Addendum No.3
to
CONSTRUCTION DOCUMENTS
for

NCISD New District Administration Building
21330 Valley Ranch Parkway
New Caney, TX. 77357
June 2, 2025

Below is a summary of the sheet and specification revisions for Addendum #3.

NOTE:
1. RE: FIXTURE SCHEDULE SHEET P-402 FOR FIXTURE ROUGH-IN SIZE.

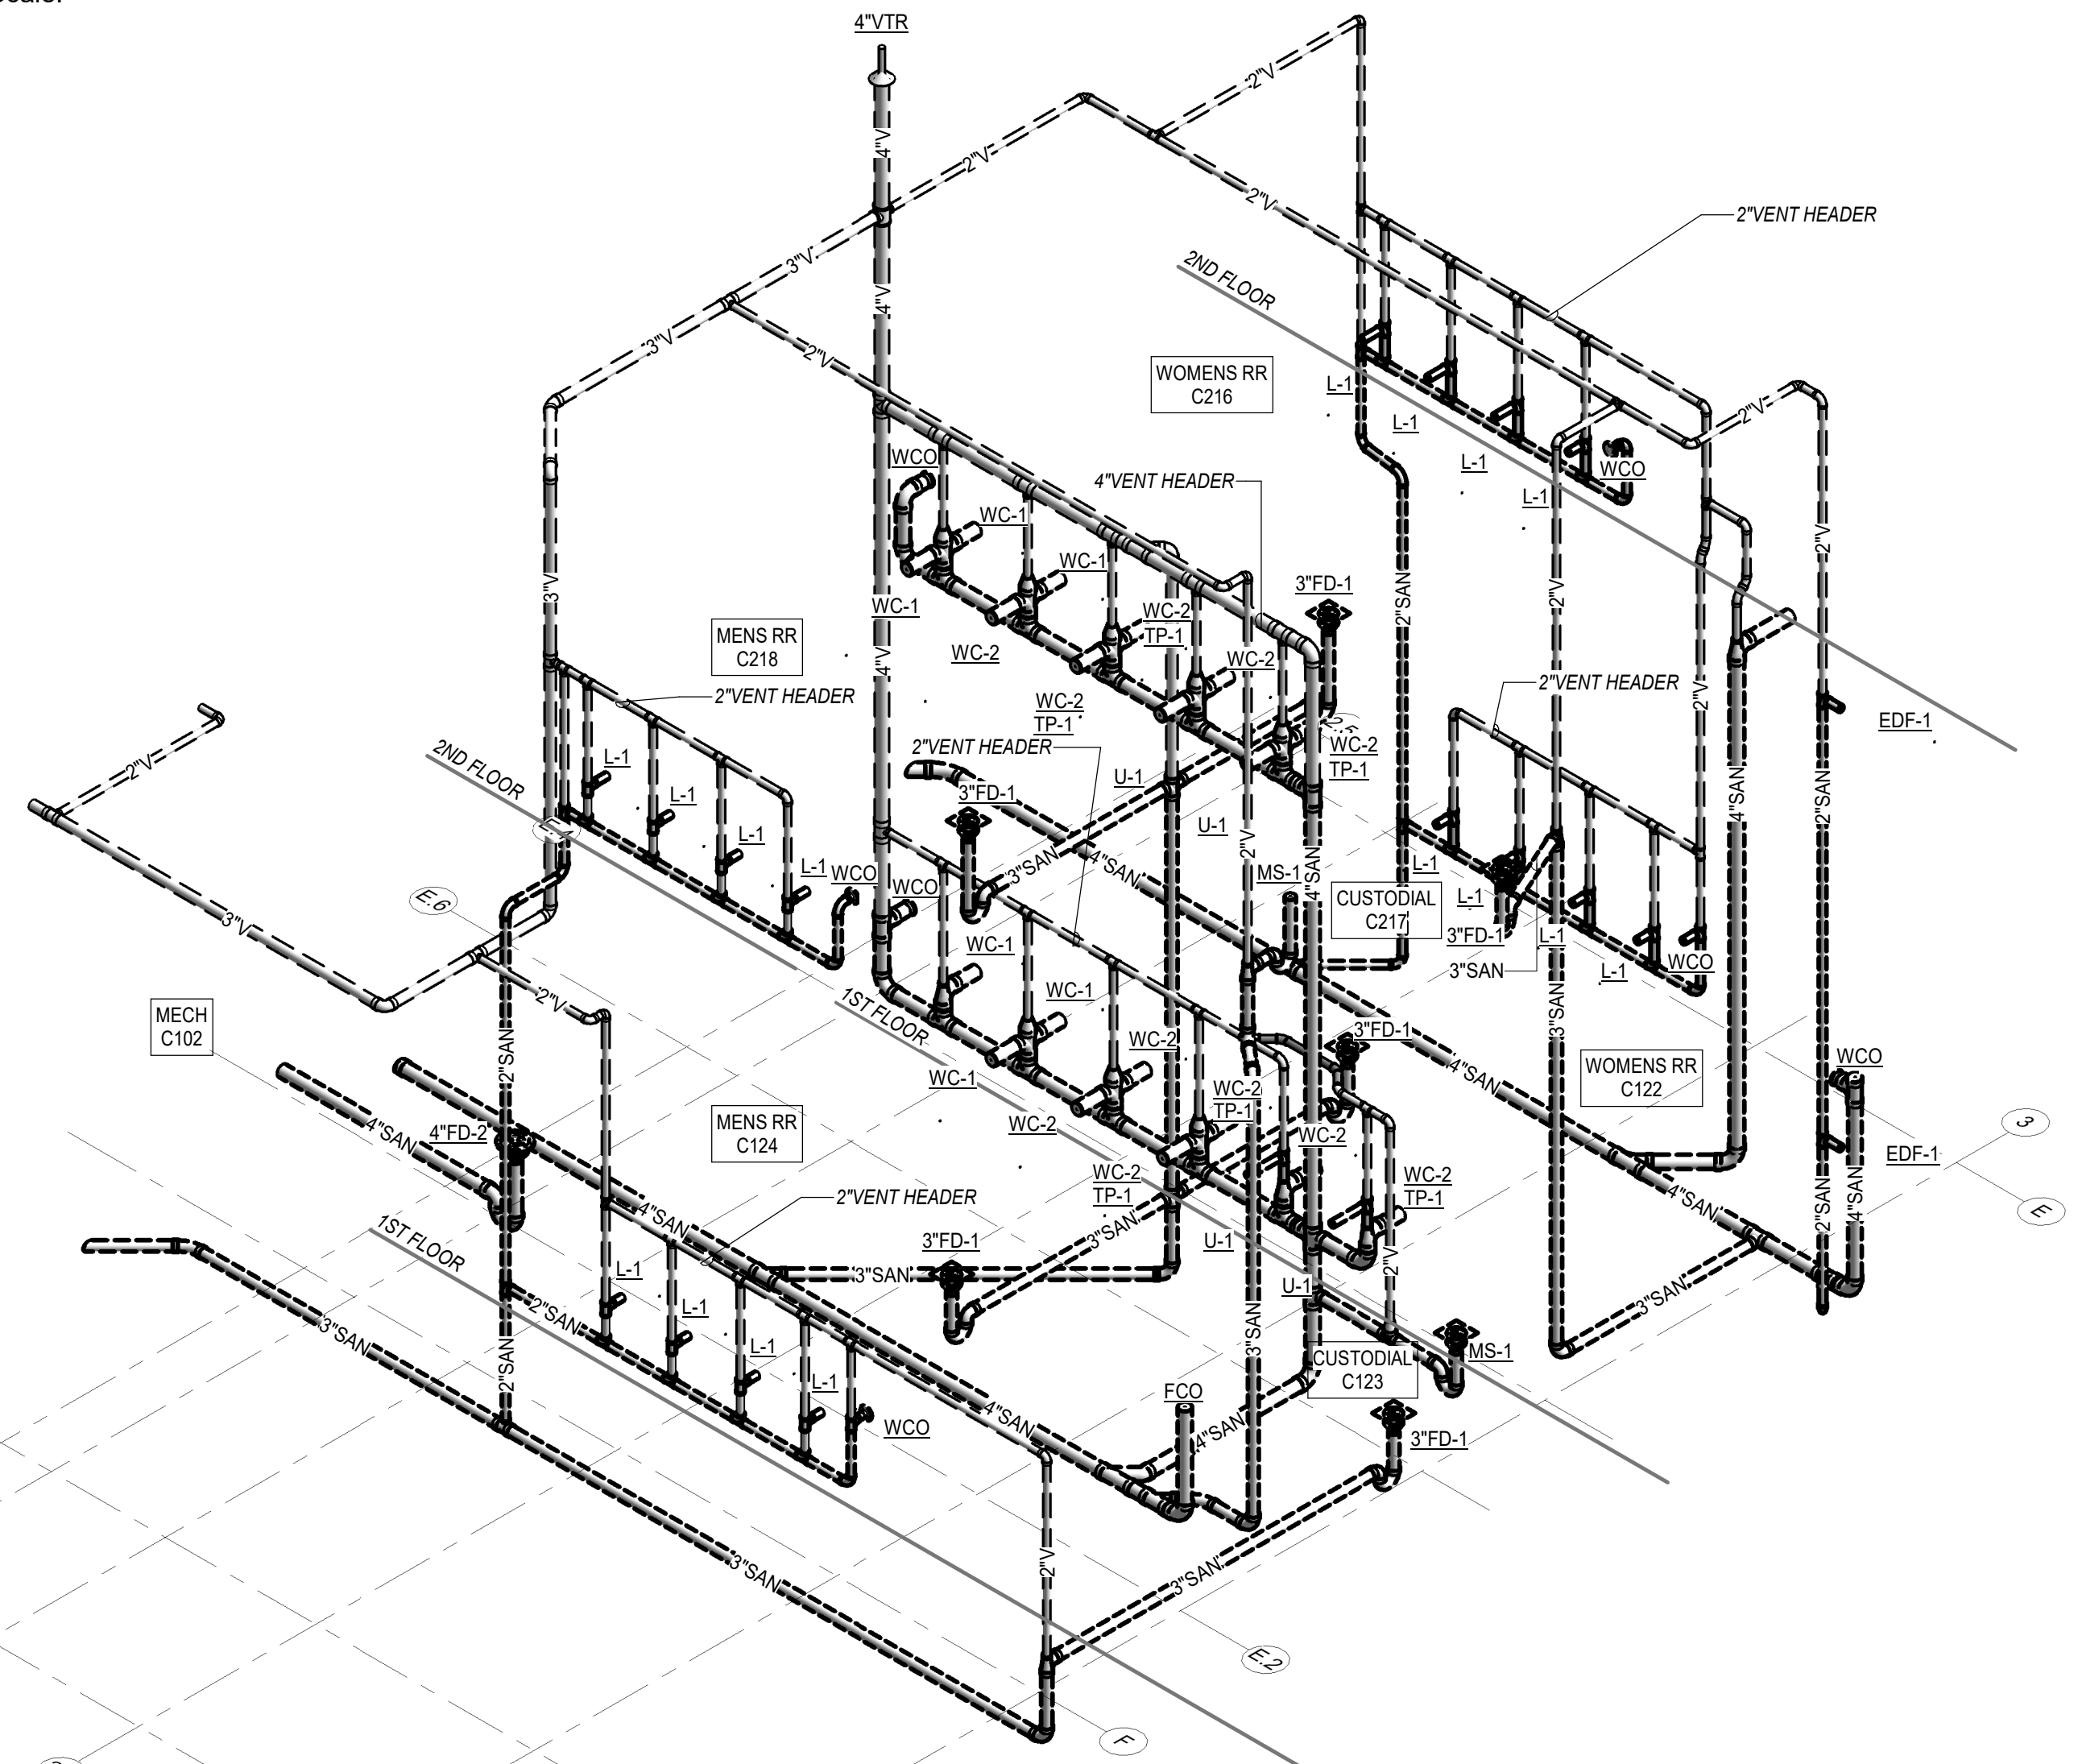
- a. Revise location of floor sinks serving units OAU-1 and AHU-4.
- 19. SHEET P-201 – PLUMBING ENLARGED FLOOR PLAN
 - a. Revise location of floor sink serving units OAU-2.
 - b. Revise gas meter location along with associated downstream gas piping.
- 20. SHEET P-501 PLUMBING RISER DIAGRAMS
 - a. VIEW #3 – GAS RISER DIAGRAM: Revise gas riser diagram reflecting new gas meter location and gas loads.
